STATE OF CONNECTICUT  
CONNECTICUT SITING COUNCIL

DOCKET NO. 499

HOMELAND TOWERS, LLC AND NEW CINGULAR WIRELESS PCS, LLC d/b/a AT&T  
RESPONSES TO INTERVENOR GREENBAUM INTERROGATORIES

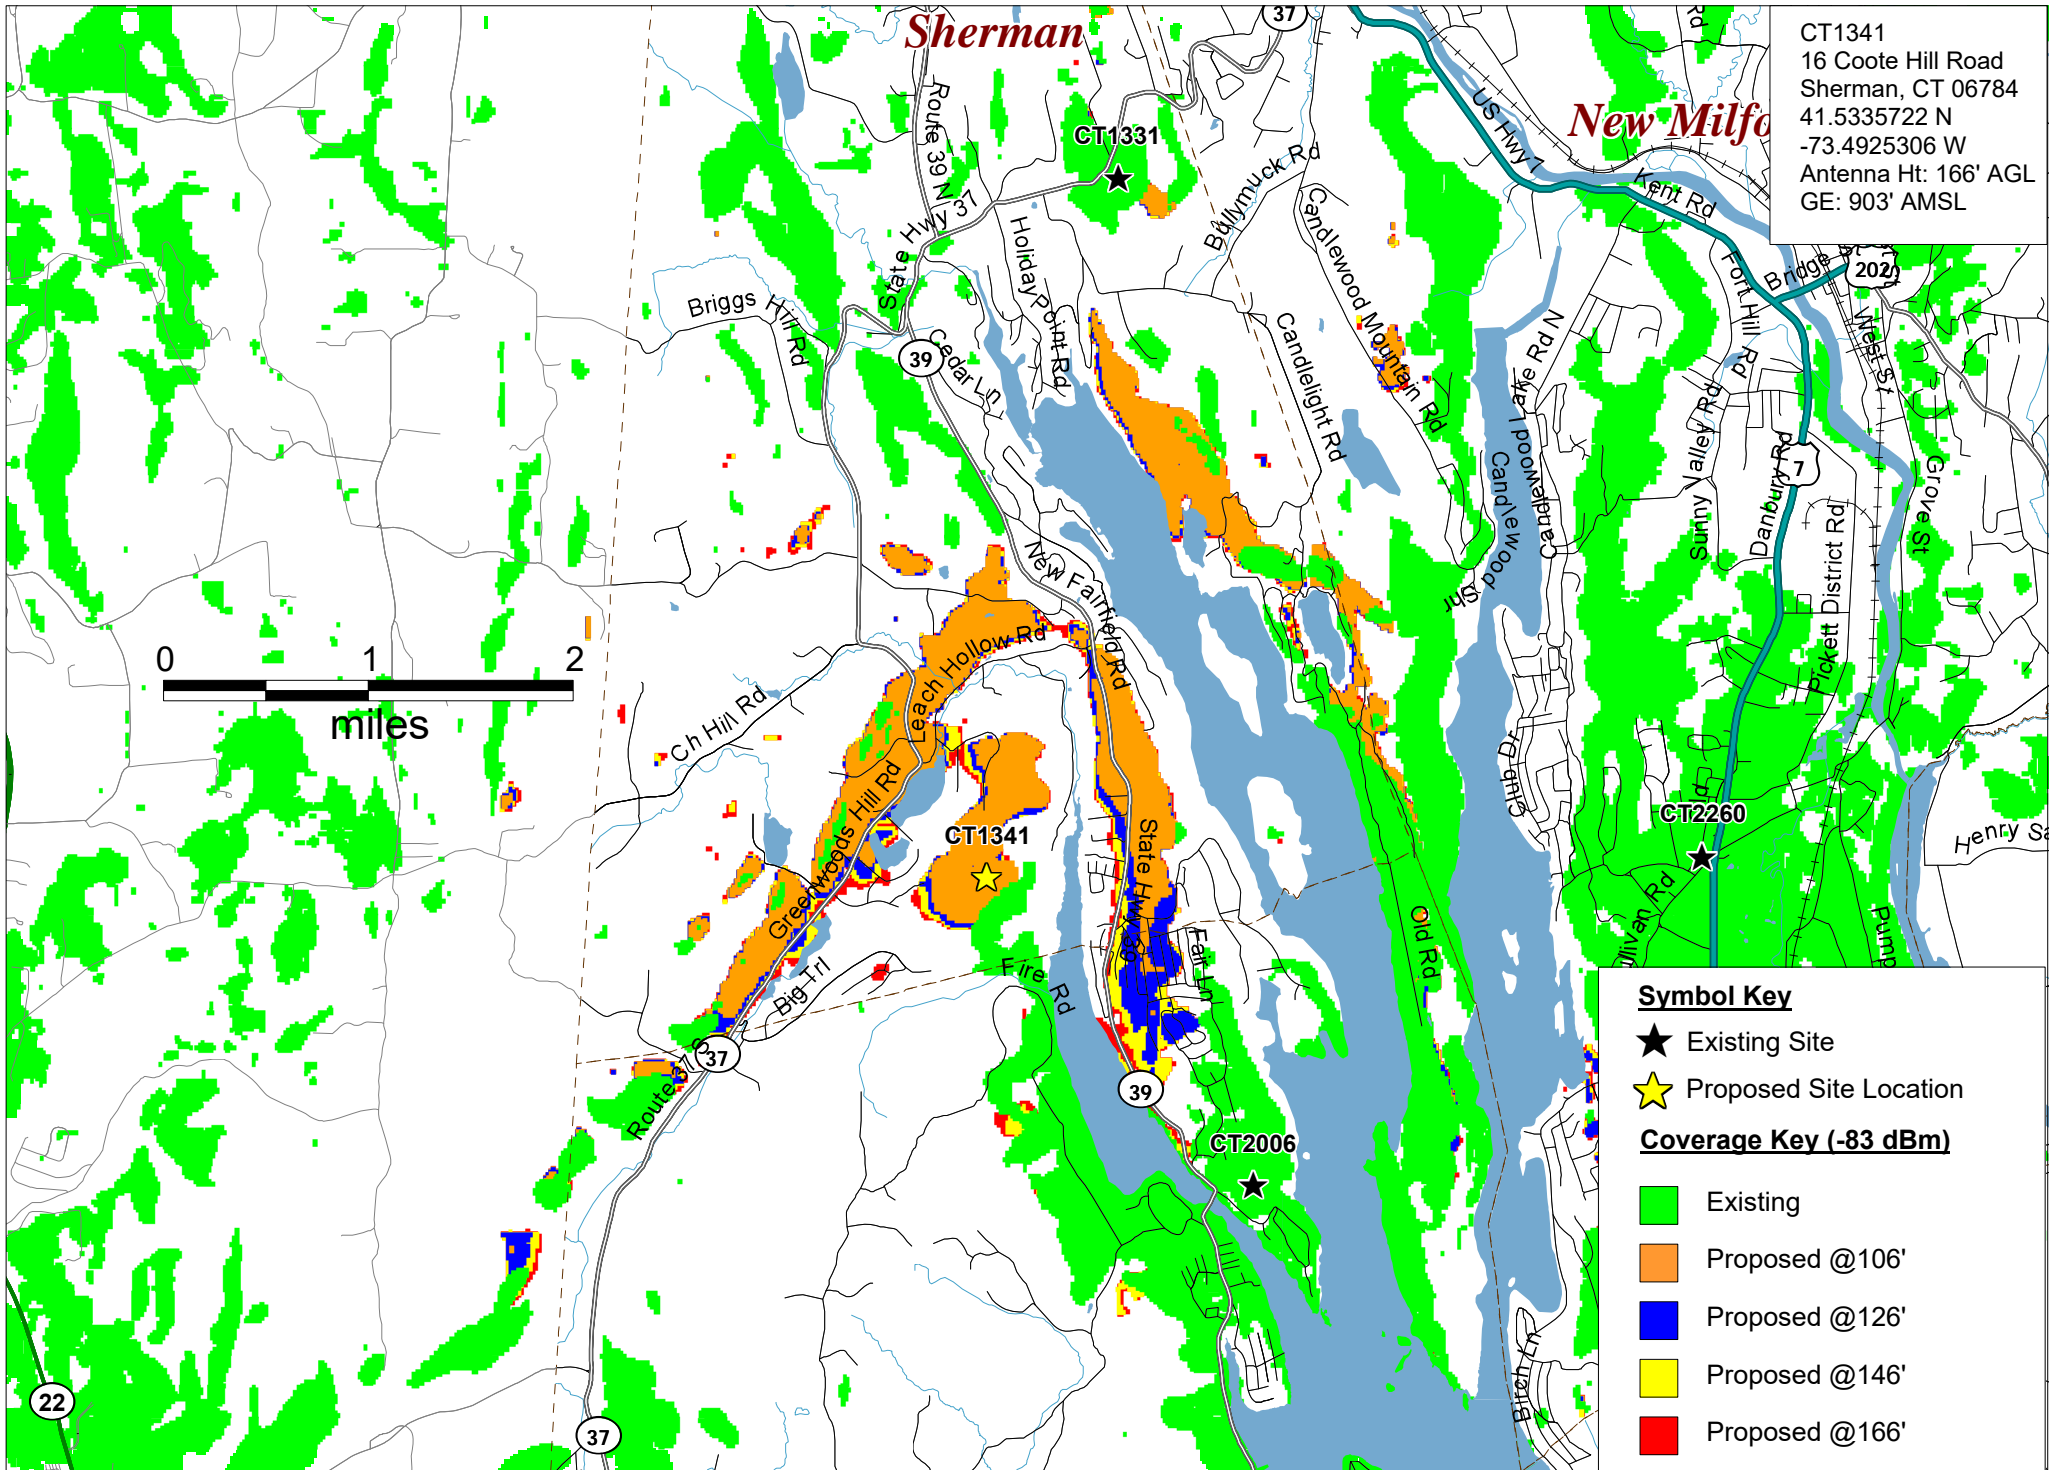
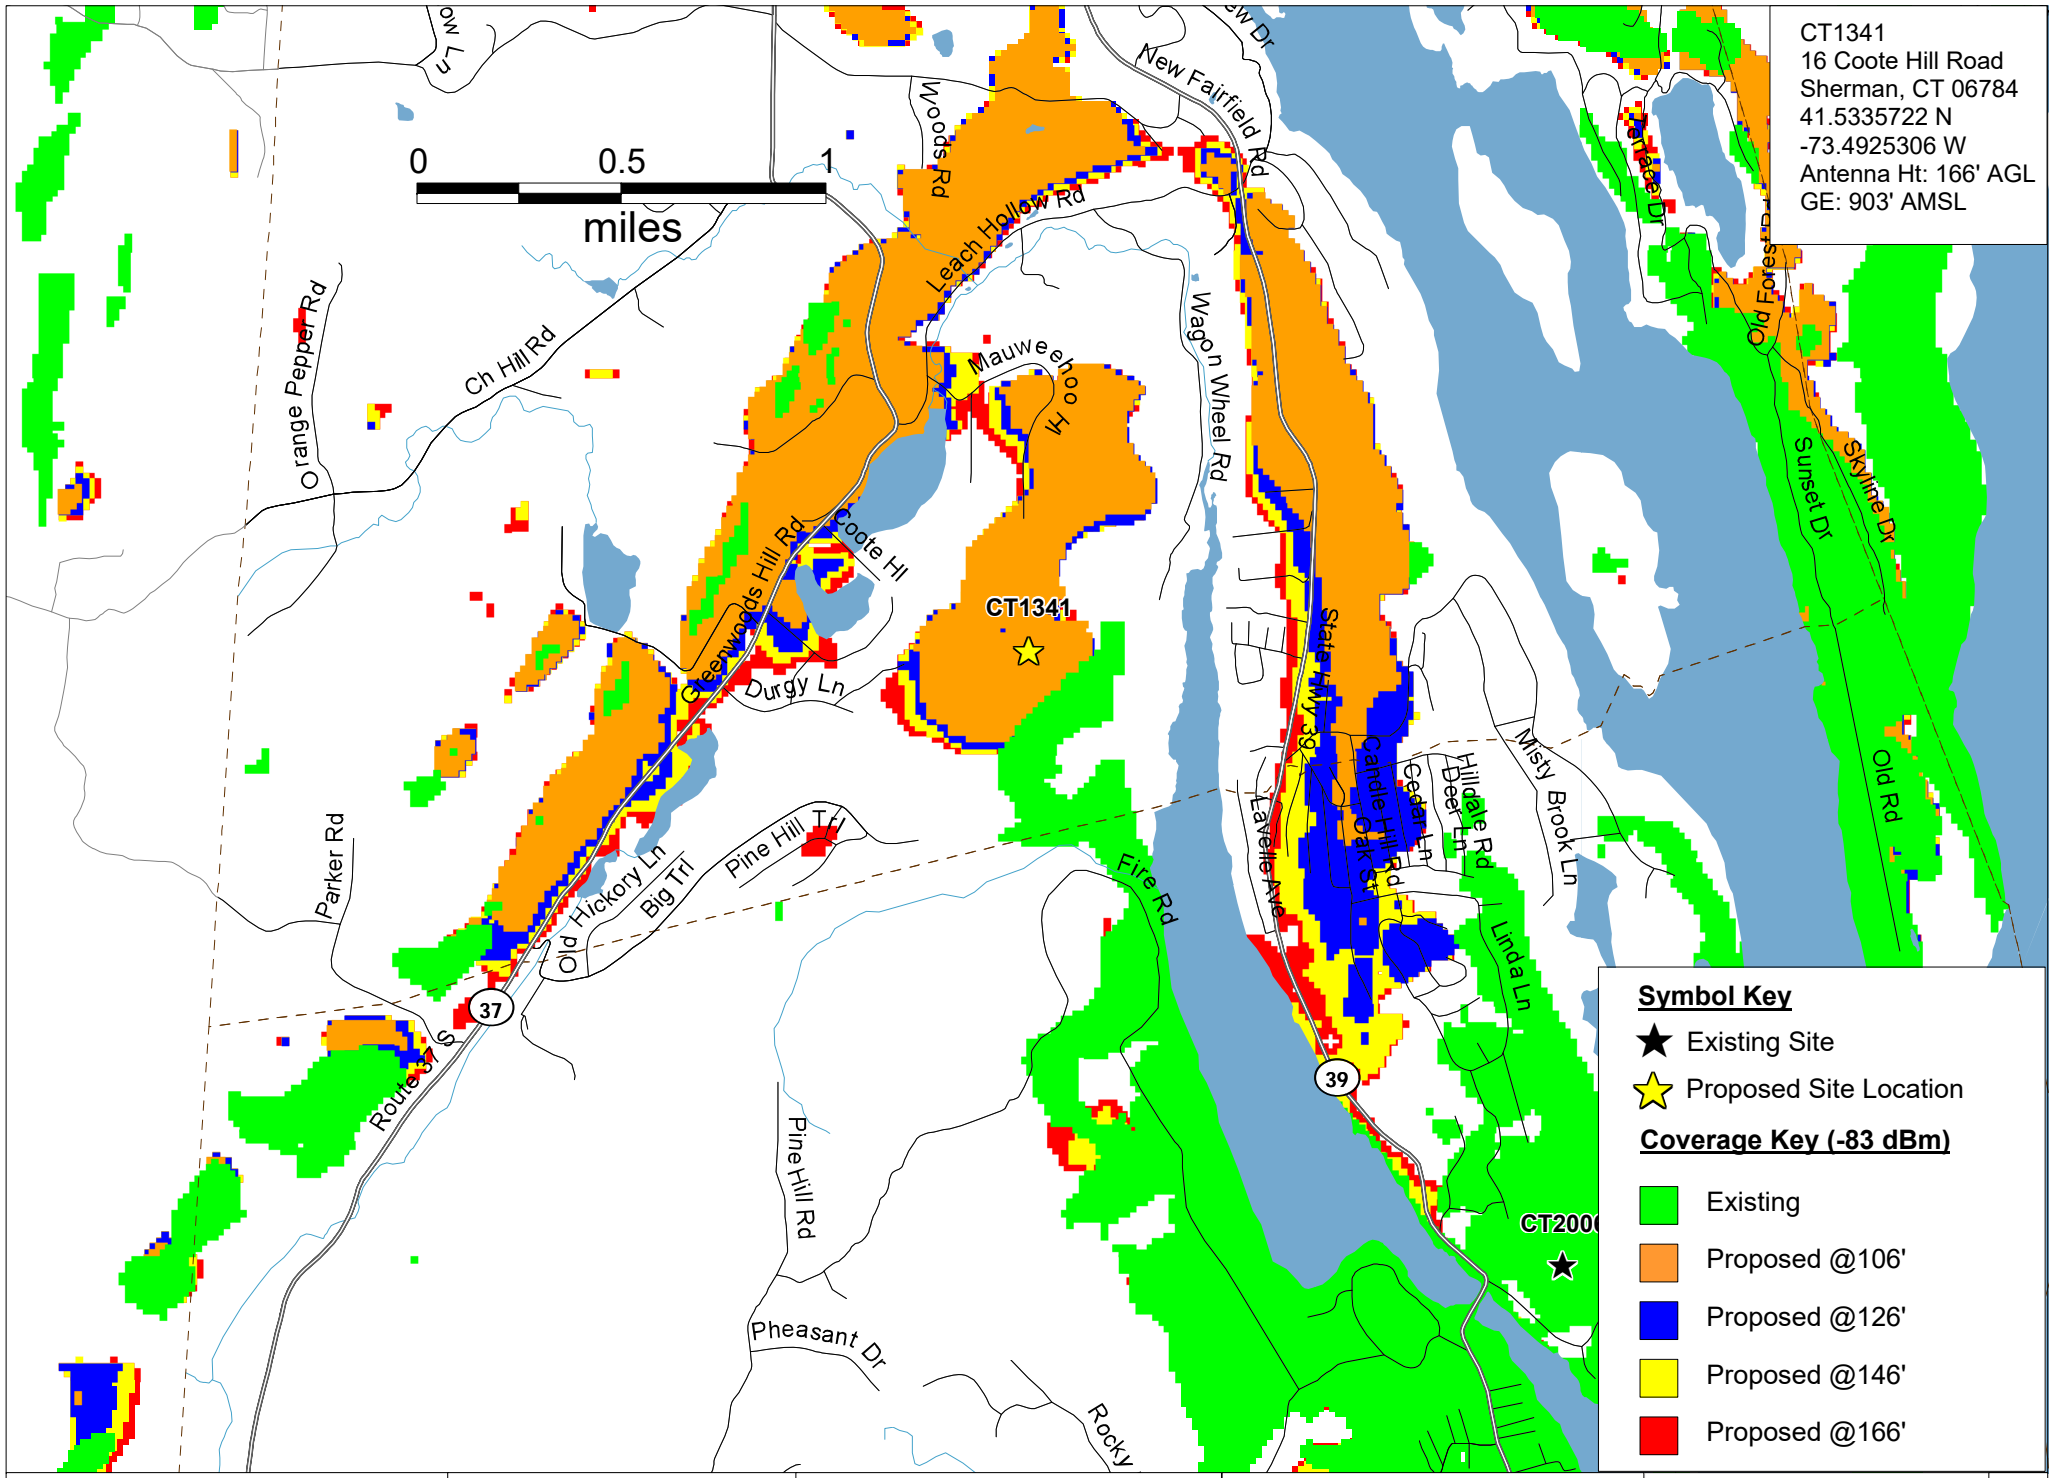
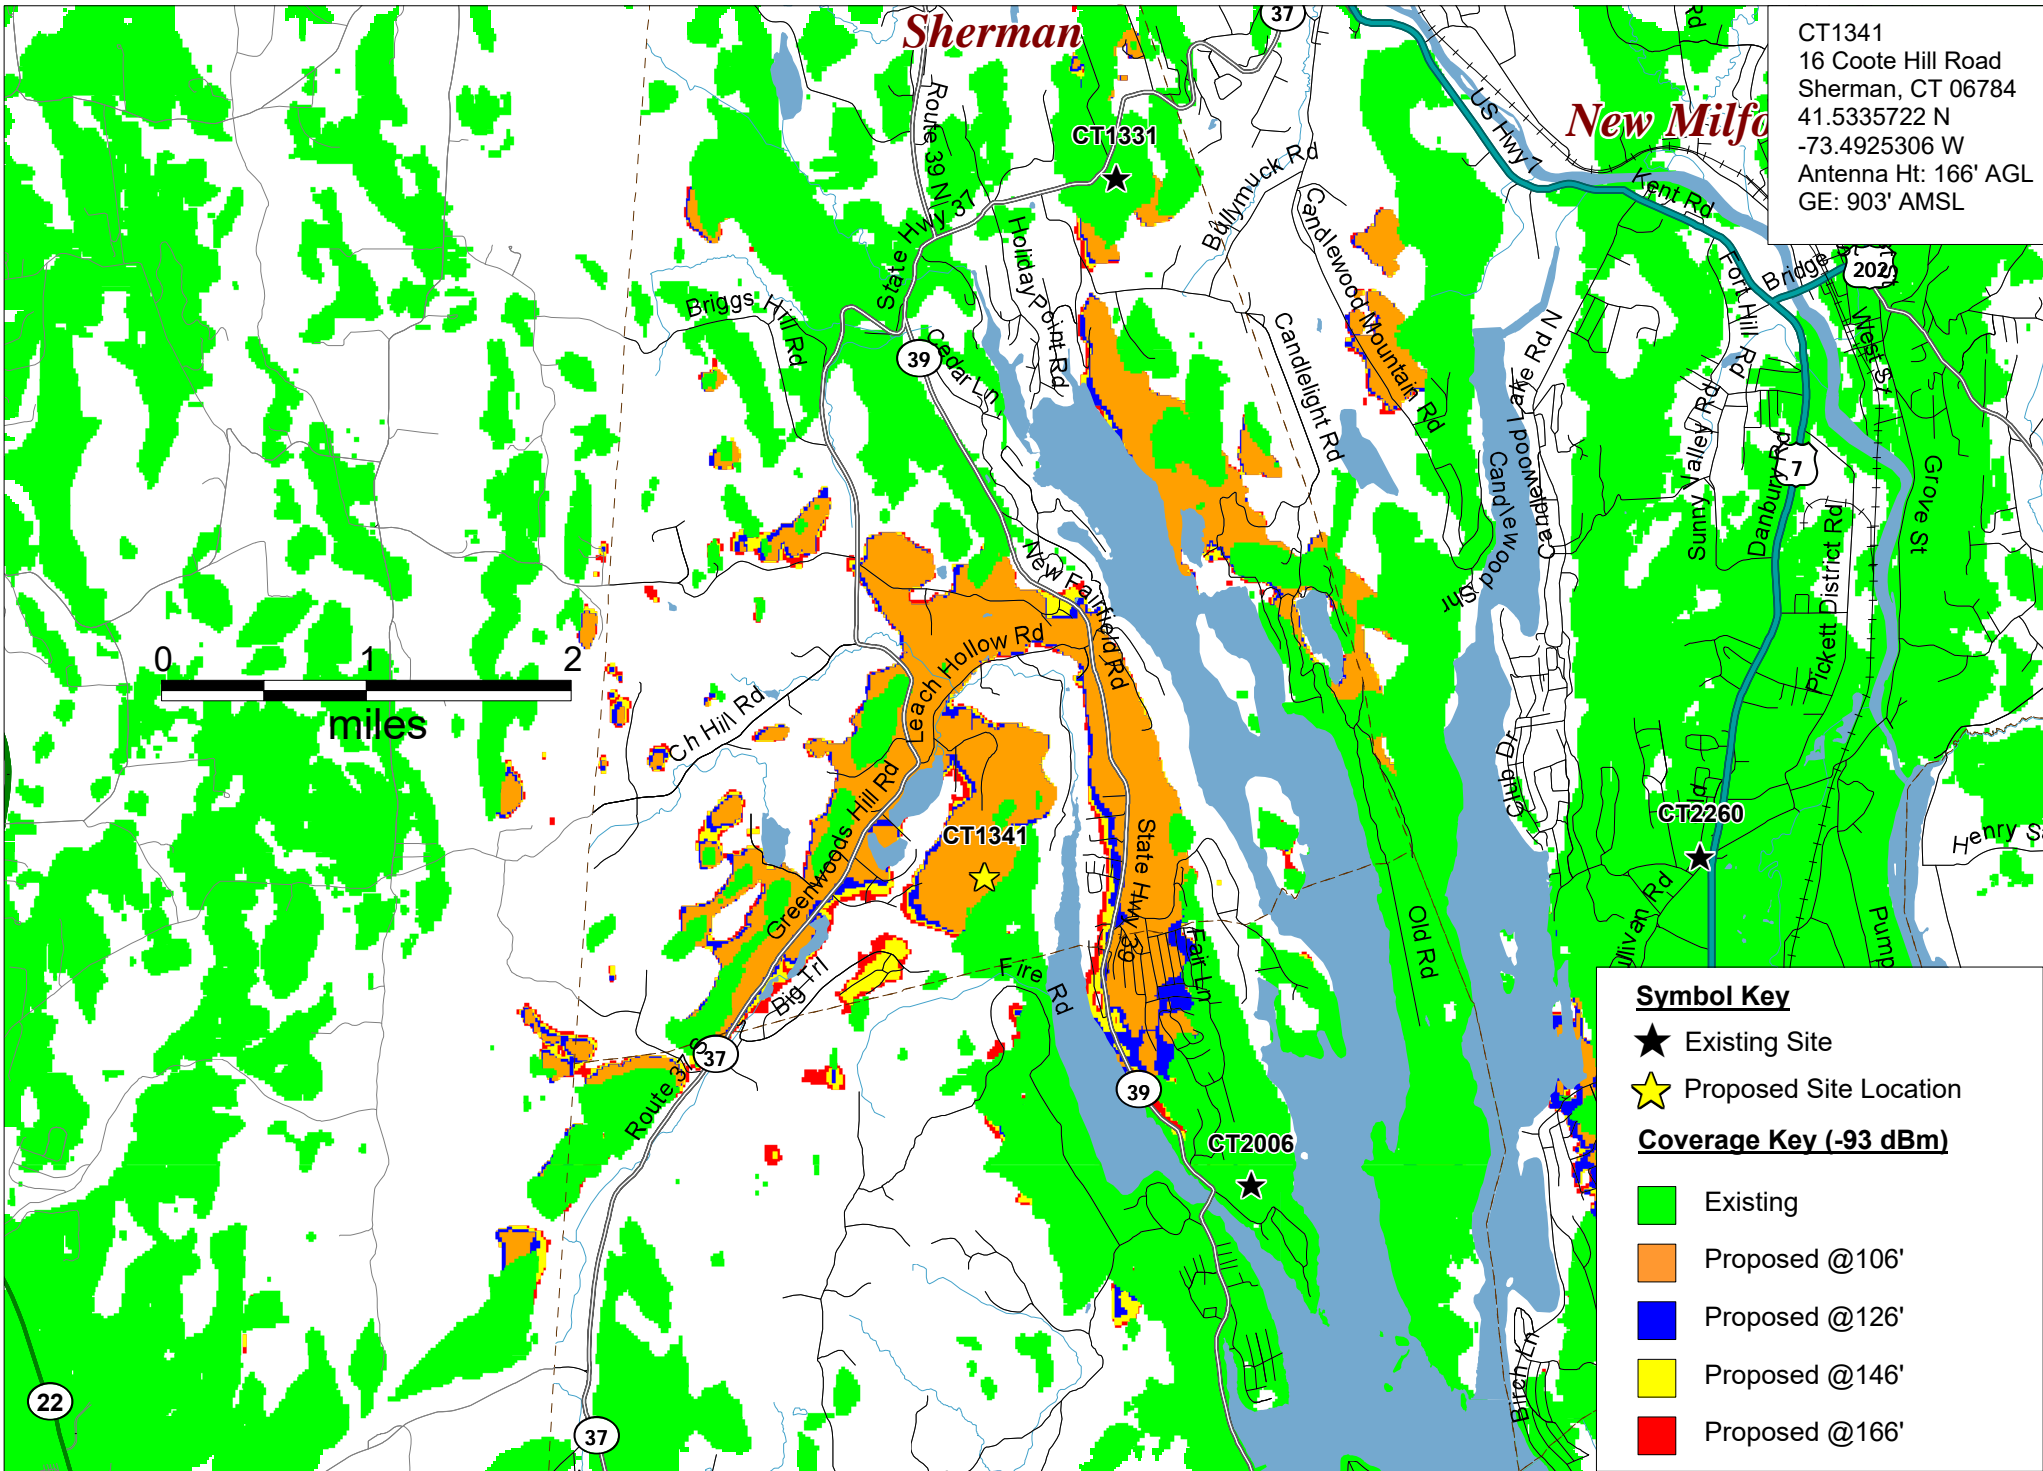
- A50. *The height of the Proposed Facility is the minimum height needed to provide service.*
- Q51. The Intervenor demands that the Applicant provide propagation data for 120', 130' and 150', the maximum height referred to in the Sherman Planning and Zoning regulations referred to above.

- A51. *Coverage plots for antenna heights of 170, 150, 130 and 110 feet AGL are included herein as Attachment 1 and sufficient for purposes of evaluating coverage including the contours between 110 and 130 feet AGL.*

- A67. *There are several heights analyzed in coverage plots included in Attachment 1 herein, including 110' AGL, which demonstrate the need for the tower height as proposed. See response #51 above. Additional coverage plots from the Applicants at these low heights will not specifically aid the Council further in its deliberations. The Applicants respectfully submit that the Intervenor may choose to submit evidence in this regard if it so chooses.*
